REGIONAL REVIEW FINDING

DATE: April 10, 2017 **ARC Review Code**: R1703211

Name of Proposal: 1105 West Peachtree (DRI 2659)
Submitting Local Government: City of Atlanta

SAP1.0

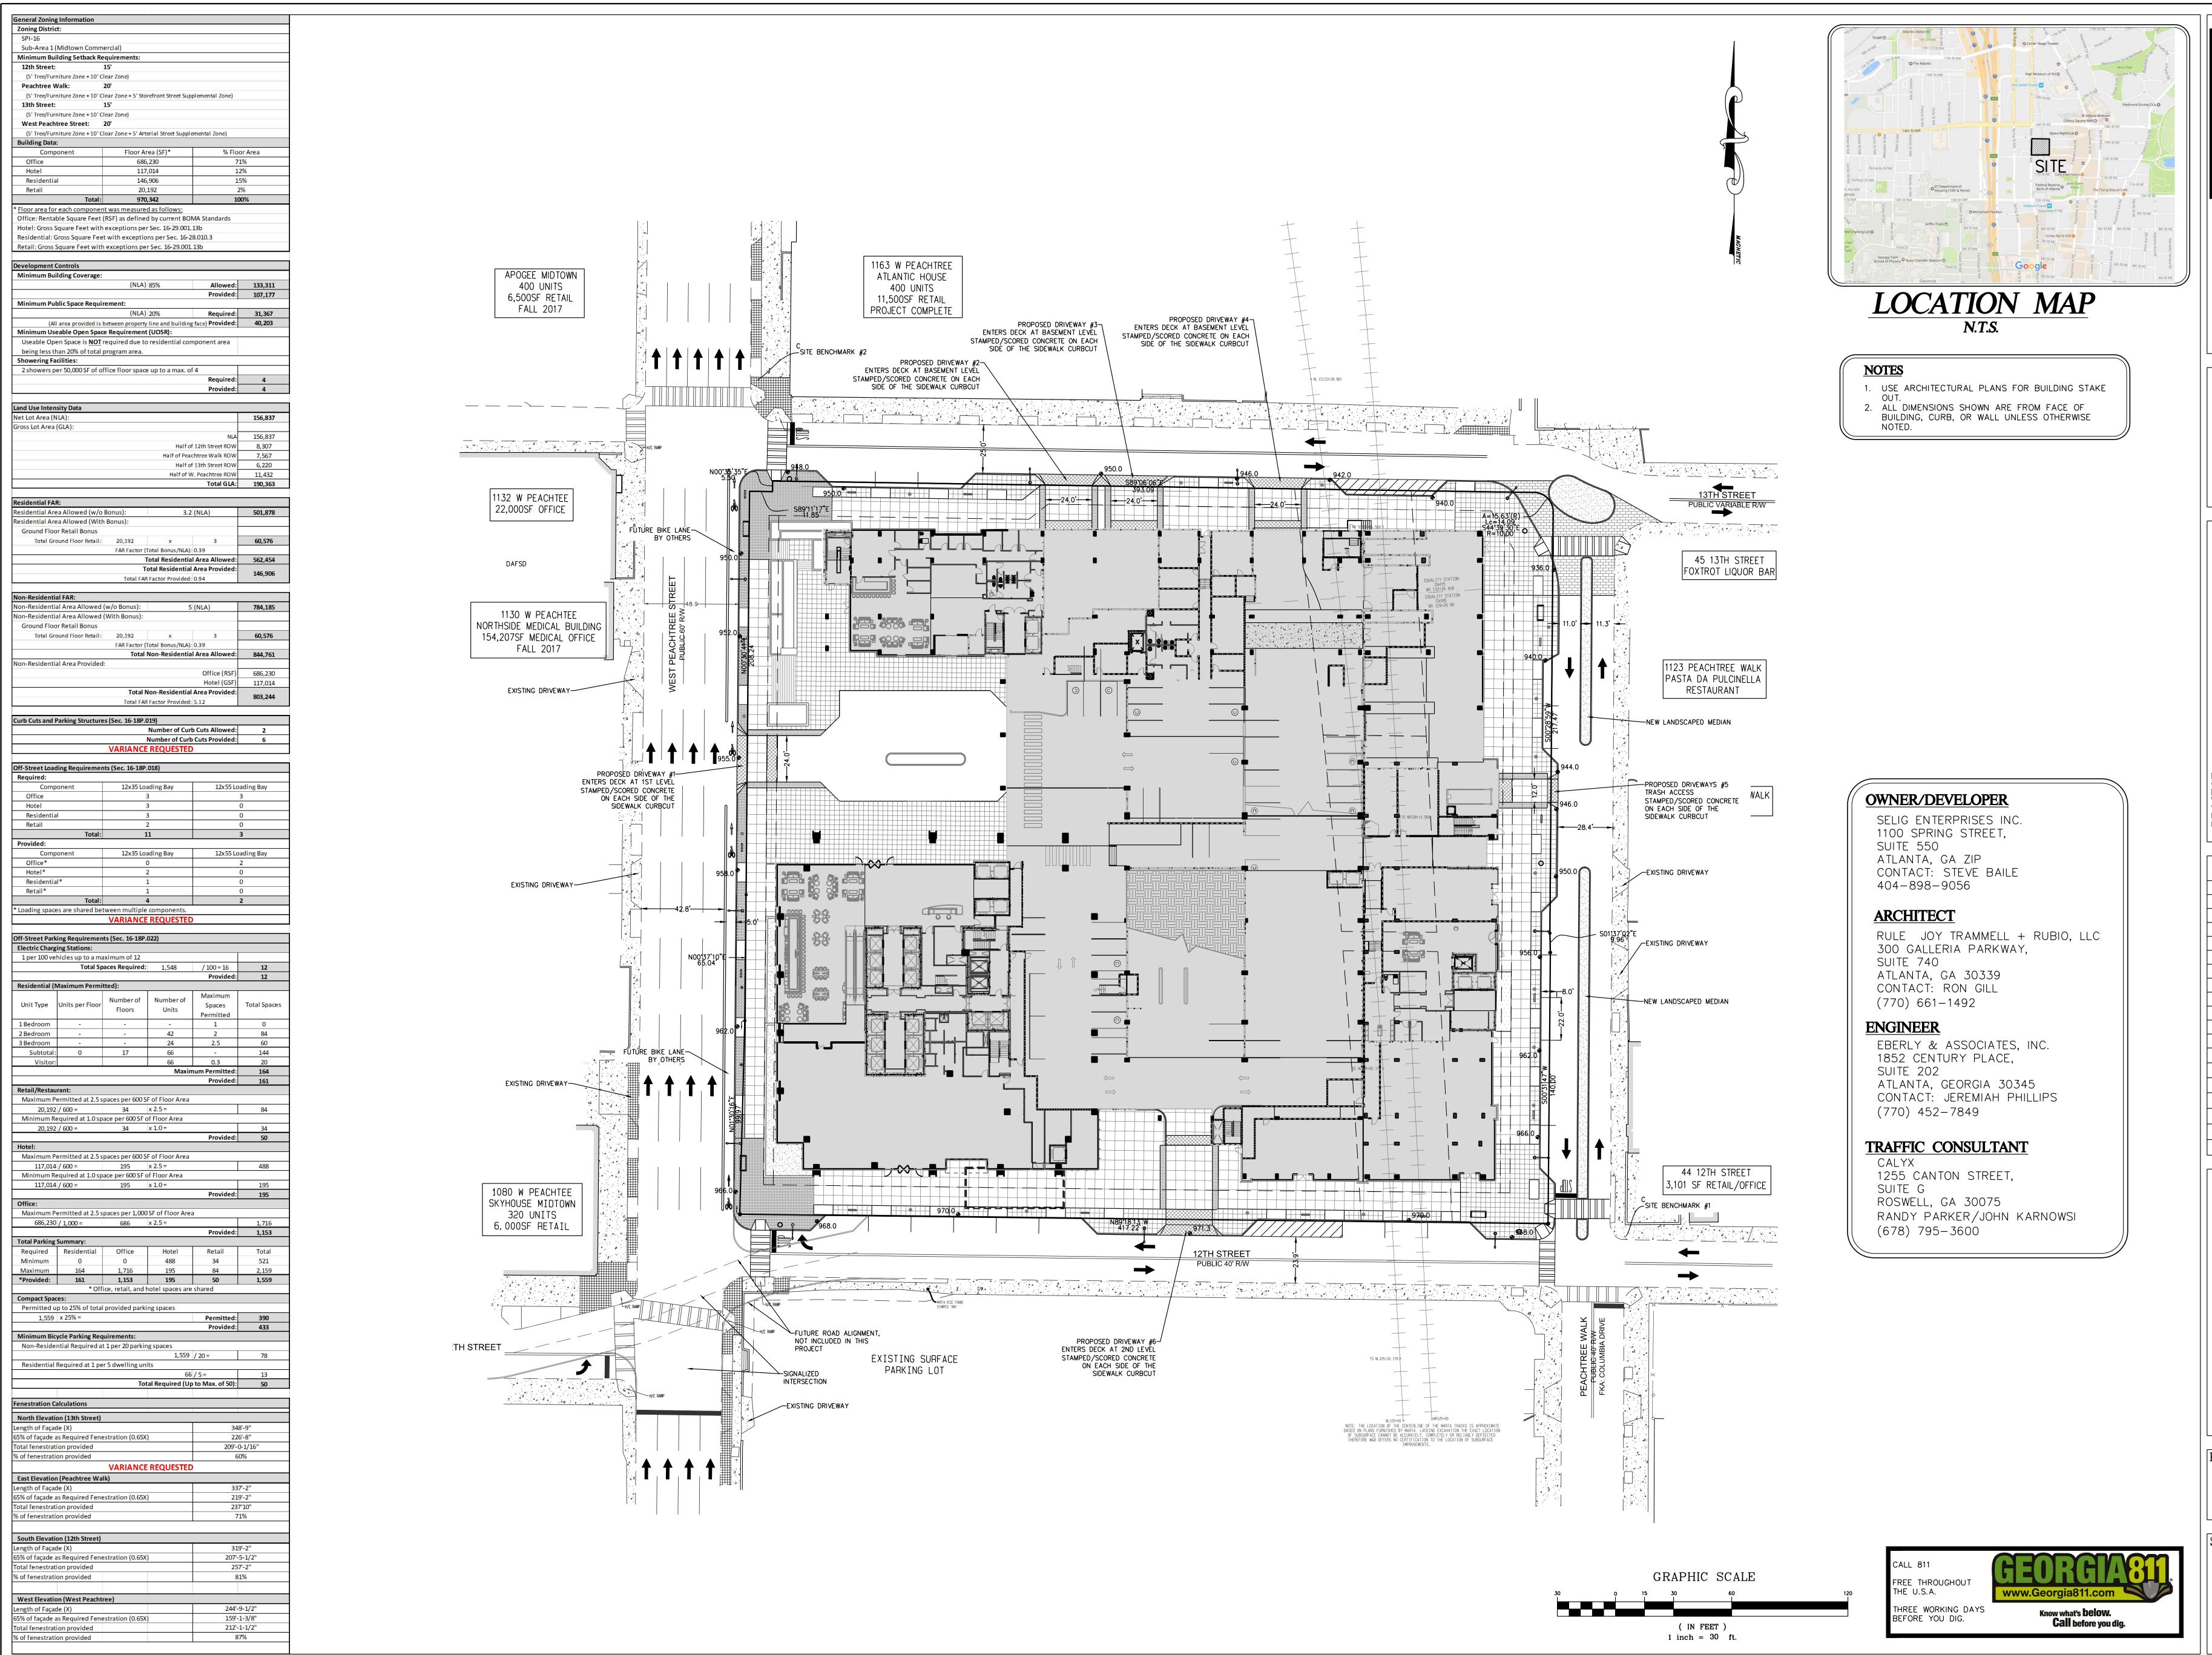
Along these lines, care should be taken to ensure that the development promotes a functional, safe, clearly marked and comfortable pedestrian experience on all streets, paths and parking areas. This includes the project's 13th Street frontage, where pedestrians will have to navigate three curb cuts (Driveways 2, 3 and 4) and associated vehicular traffic within a short segment of one block. It also includes the project's West Peachtree Street frontage where cyclists in the planned West Peachtree Street bike lane will have to cross Driveway 1 and associated vehicular traffic. The development team is also encouraged to ensure that end-of-trip facilities (bicycle racks, etc.) are provided for residents, workers and visitors at key locations throughout the site. In general, the project proposes significant pedestrian amenities on all frontages.

The project proposes three full movement access points within 140 foot span of the property frontage along 13th Street. In the interest of safety and to reduce the adverse effects on traffic flow, consider reducing the number of access points.
